Title: Advisory Committee on Reactor Safeguards
Plant License Renewal Subcommittee

Date: Tuesday, October 3, 2006

ADVISORY COMMITTEE ON REACTOR SAFEGUARDS (ACRS)
MEETING OF PLANT LICENSE RENEWAL SUBCOMMITTEE

Sand Bed Area

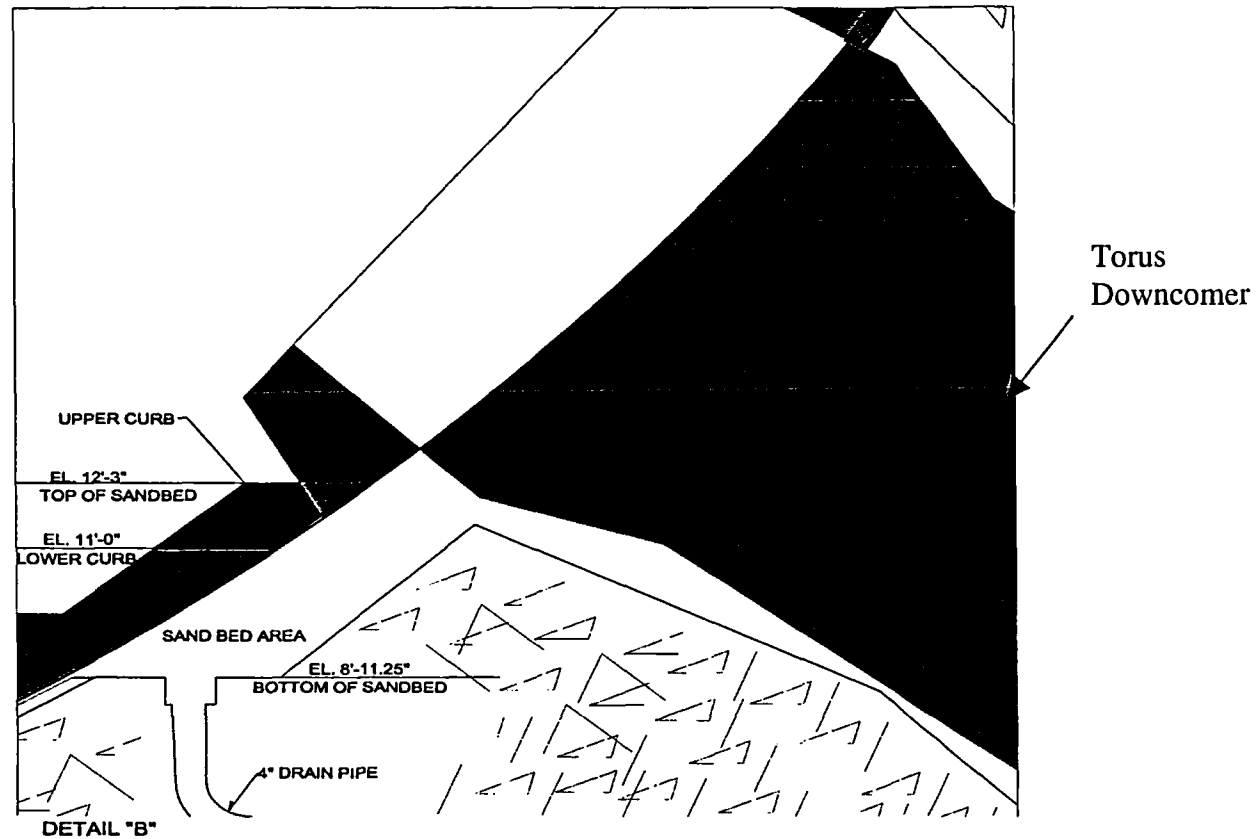
3 MR. GALLAGHER: Well, there is an air gap
4 there and so there is -- there was air or there is
5 air. If I go to Slide 10 and this will be hitting
6 into your questions. Slide 10 is a close-up of the
7 cross-section of the sandbed. Your questions will be
8 answered in the next slide, but this shows the sandbed
9 area and the drain. The air gap is also shown and
10 that's the red at the top of the slide.

16 MEMBER SHACK: Just while we have this
17 drawing up, now, my understanding is you didn't have
18 a galvanized plate the way some people do to cover the
19 sandbed but is that a galvanized or is that some sort
20 of plate I see there in the drawing?

Reactor Cavity Seal Area

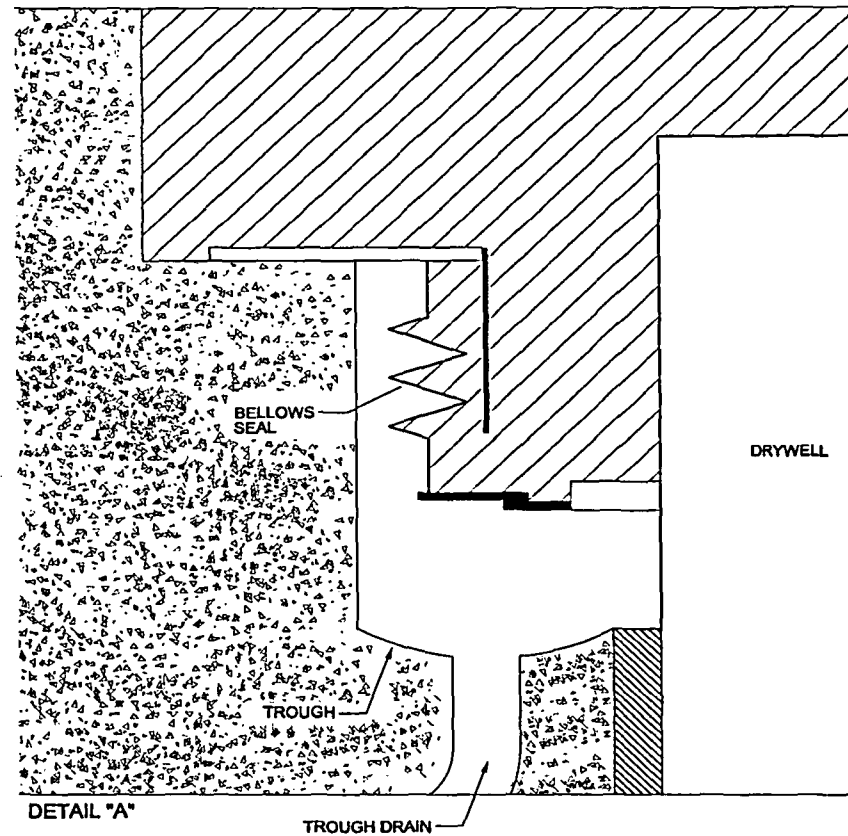
13 MEMBER BONACA: And then the question I
14 had was, the seal is supposed to be preventing water
15 penetration but if you have cracks in the liner you
16 are defeating the design objective. And the question
17 I'm raising is because whatever you do to control
18 corrosion, to do whatever you can do to monitor, you
19 still are defeating the design objective and fitting
20 water through that gap. I mean, is that an initiative
21 to try to fix those cracks or replace the liner?

13 MR. GALLAGHER: Okay, so to get to your
14 question on the next slide, which is Slide 12, excuse
15 me, Slide 11, this is the reactor cavity seal area.
16 And this -- this shows a cross section of that. This
17 slide is useful to show the water leakage path. And
18 basically as we indicated, the water leakage was
19 through defects in the reactor cavity liner and worked
20 its way into the trough area. Again, this projector
21 is light but I think your slides are a little better.

Identified Concerns

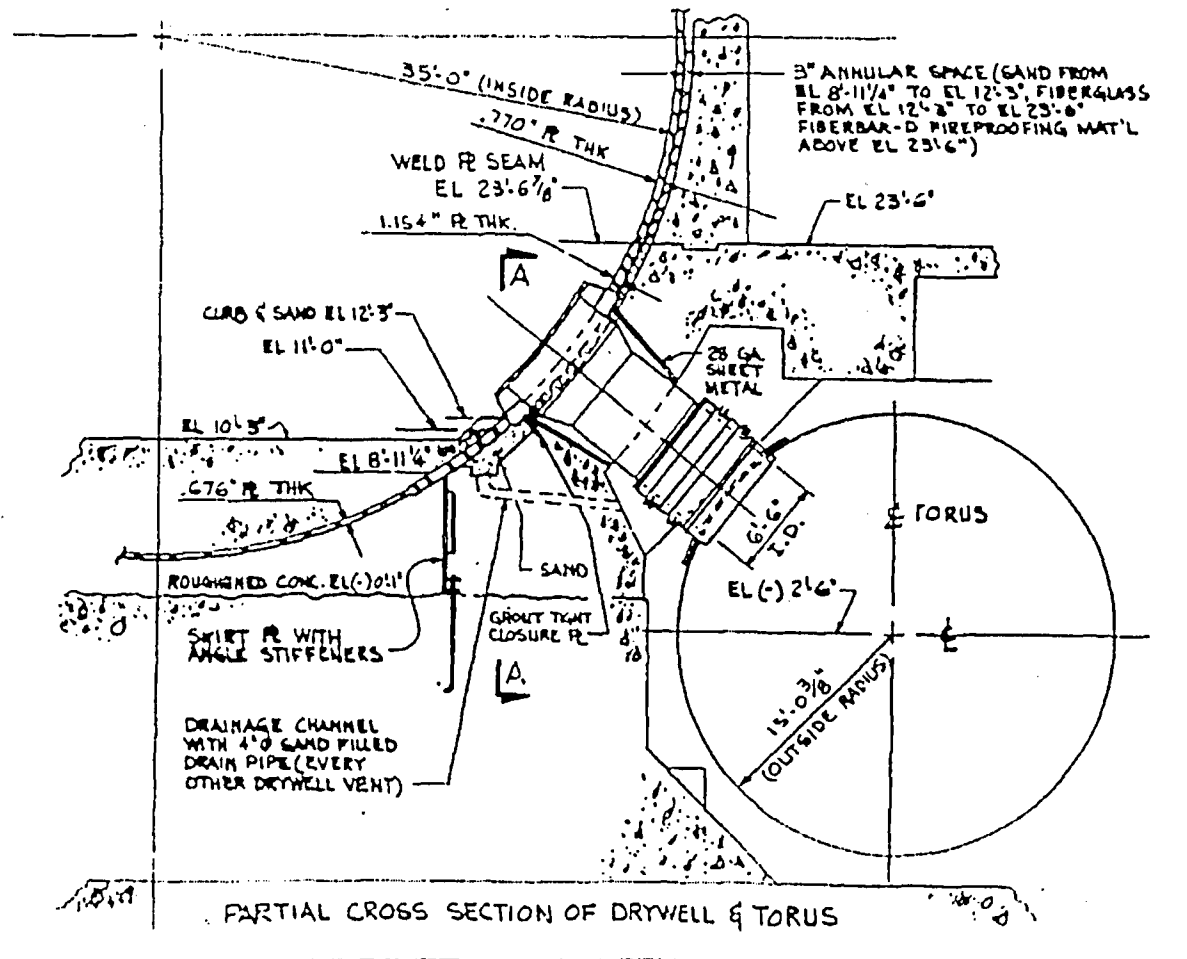
- Possible corrosion in the embedded region
 - concern covers both current safety and potential for future undetected degradation
- Sandbed region
 - whether the drywell liner meets safety margins now; and, if so
 - whether any significant degradation in the future would be detected before safety margins are violated – subject of contention

Second Possible Failure Mechanism

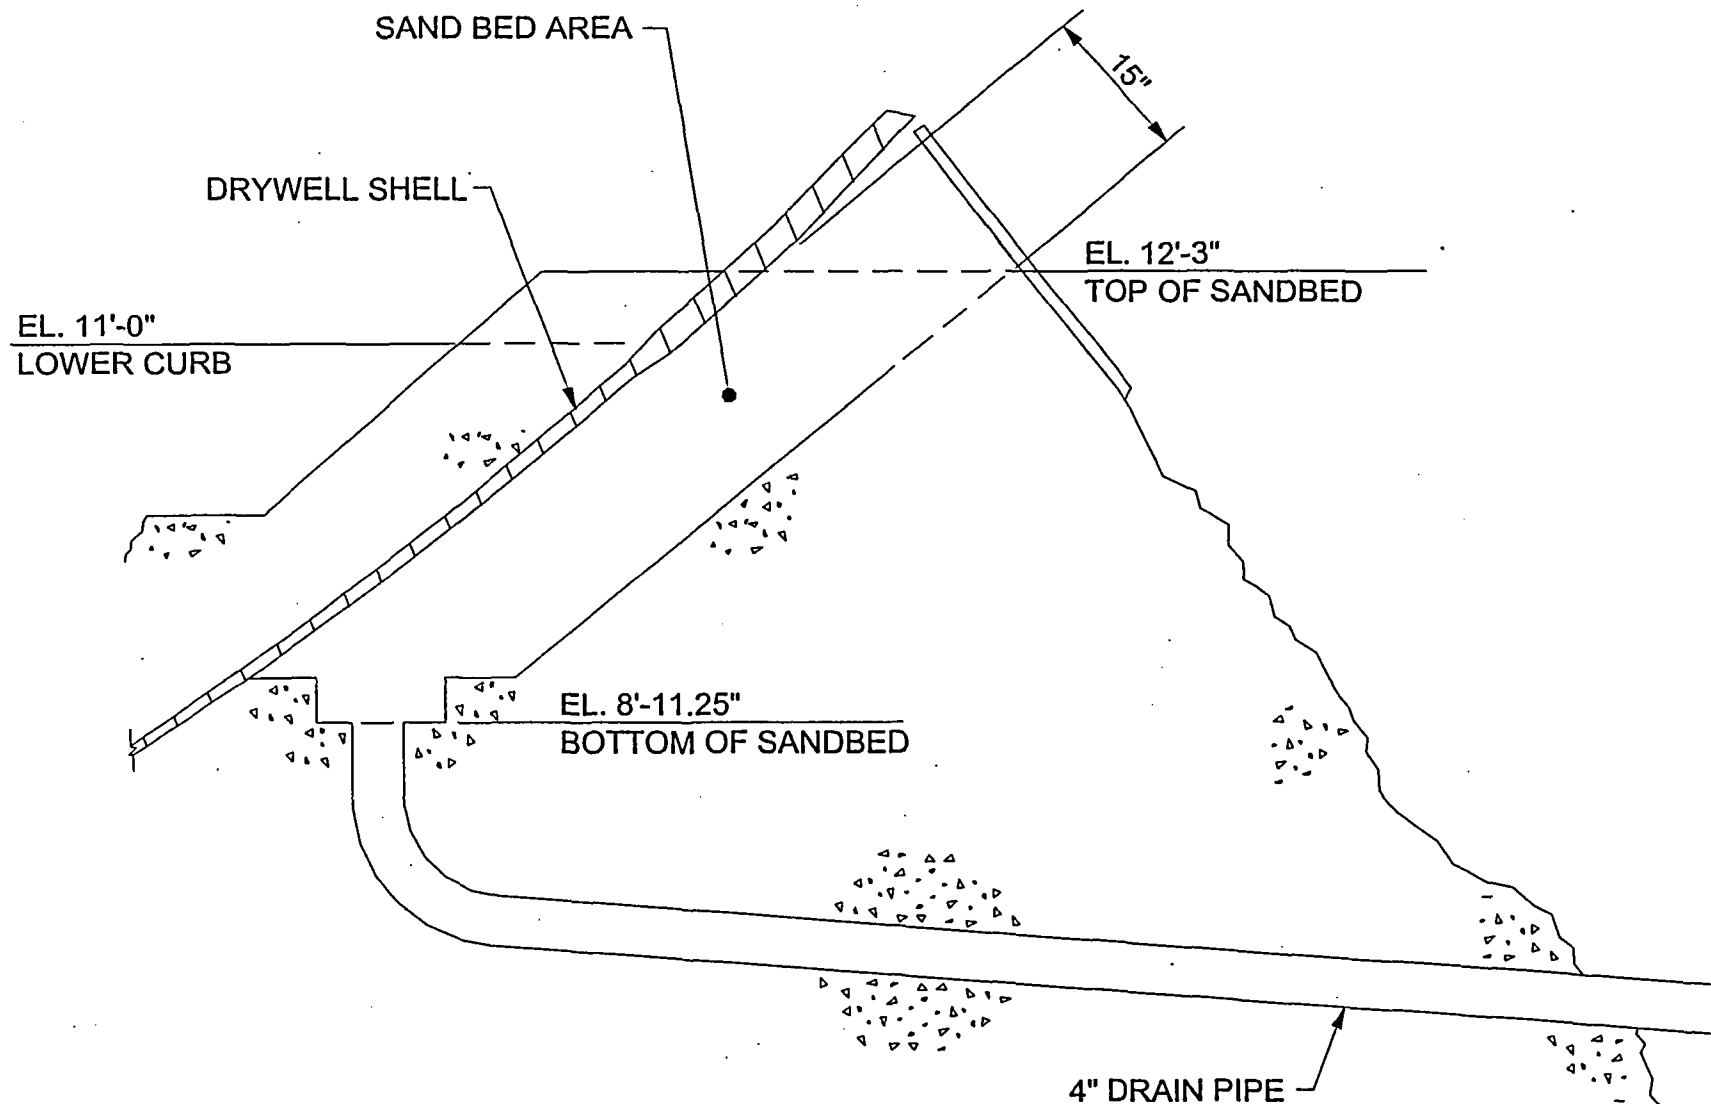
- **Chloride induced fatigue cracking is possible**
- **It will be necessary to examine both the corroded areas and susceptible areas for the existence of stress corrosion cracks in the drywell liner**
- **Nothing yet proposed to resolve this issue**
